SUBJECT: Michigan Department of Environment, Great Lakes, and Energy (EGLE)
Comments on Proposed Remedial Design and Approach for the
Environmental Protection Agencies (EPA's) Sediment Alternative-
Alternative S-3A, Operational Unit 5 (OU5) Area 1, Allied Paper,
Inc./Portage Creek/Kalamazoo River Superfund Site

**OU-5 Area 1, Allied Paper, Inc./Portage
Creek/Kalamazoo River Superfund Site, EGLE
Comments on Proposed Remedial Design and
Approach for EPA's Selected Sediment
Alternative - Alternative S-3A**

Verburg Park Pond Dredge Prisms

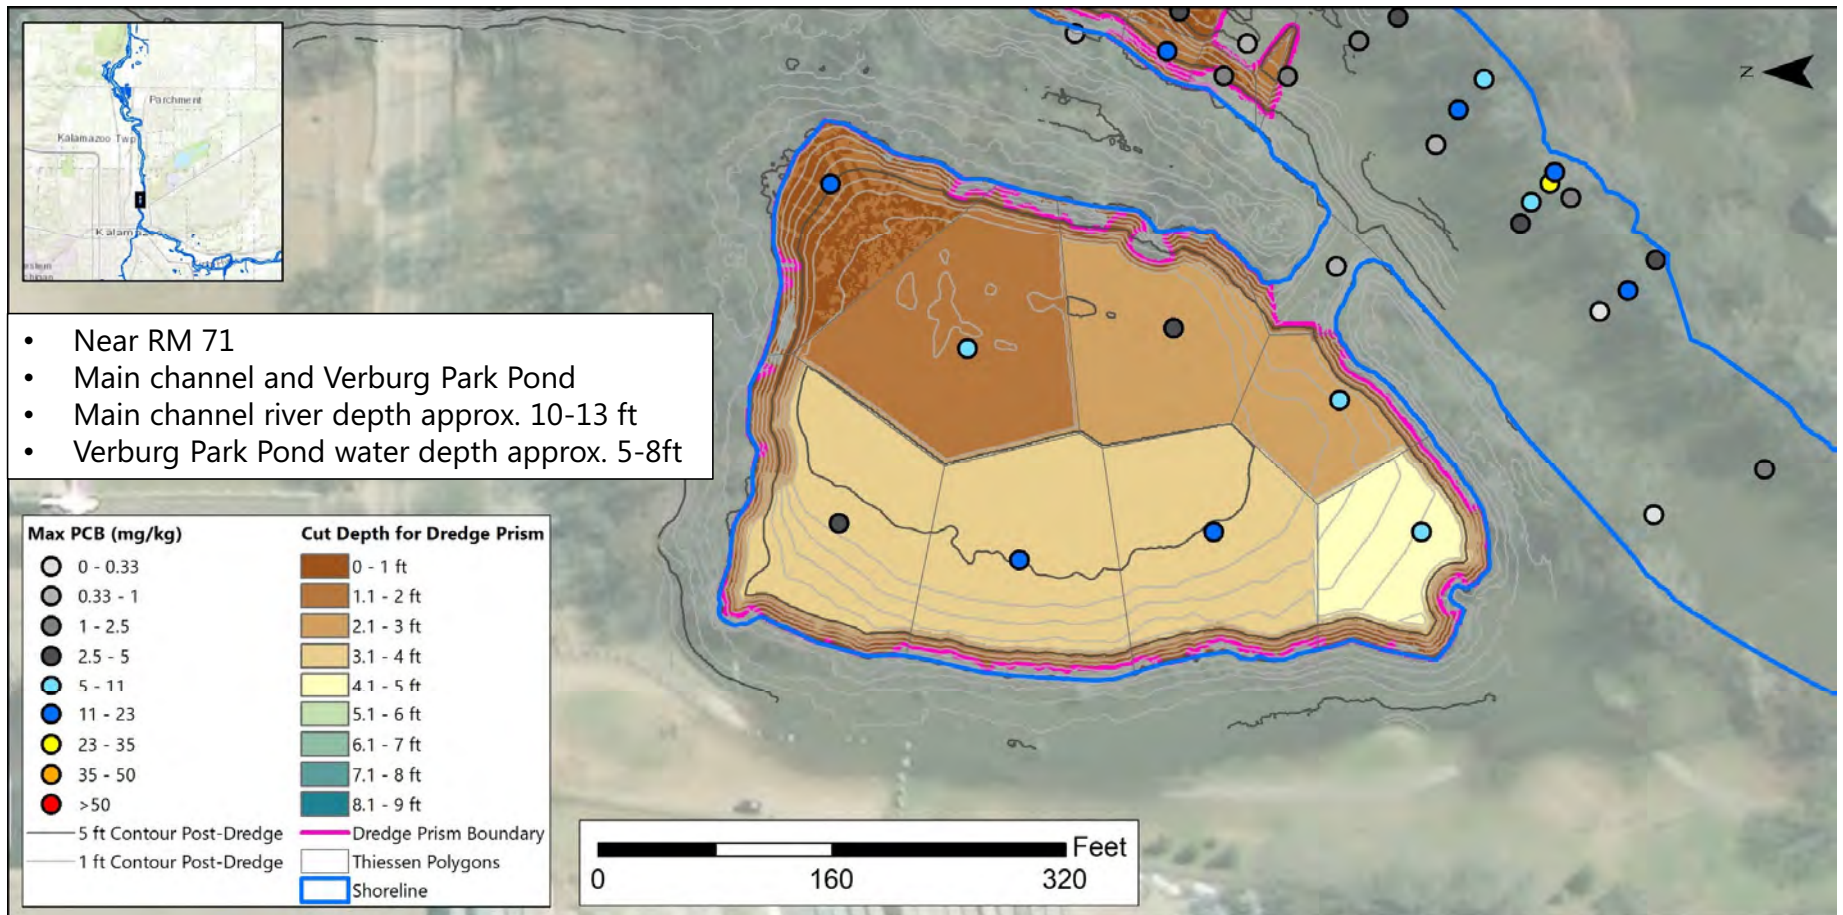
- Both Verburg Park (February 5 Presentation, Slide Figure 12) and Crowne Vantage Side Channel (February 5 Presentation, Slide 7) (attached) could be considered to function as sediment traps and, as such, depth of contamination would be expected to be fairly consistent throughout each area.^{1,2}

- This conceptual model should be considered when developing dredge prisms, as opposed to a point-by-point, legalistic interpretation of a small number of individual cores defining sharp breaks in dredge elevations that may reflect little more than random variation between adjacent cores. Lacking more resolved sampling, particularly in Verburg Park, a more practical and reliable dredge cut elevation should be based on an upper percentile of the depth of contamination distribution in these areas. Ideally, small analytical variations between adjacent Thiessen polygons should not drive large changes in corresponding dredge prism depths.
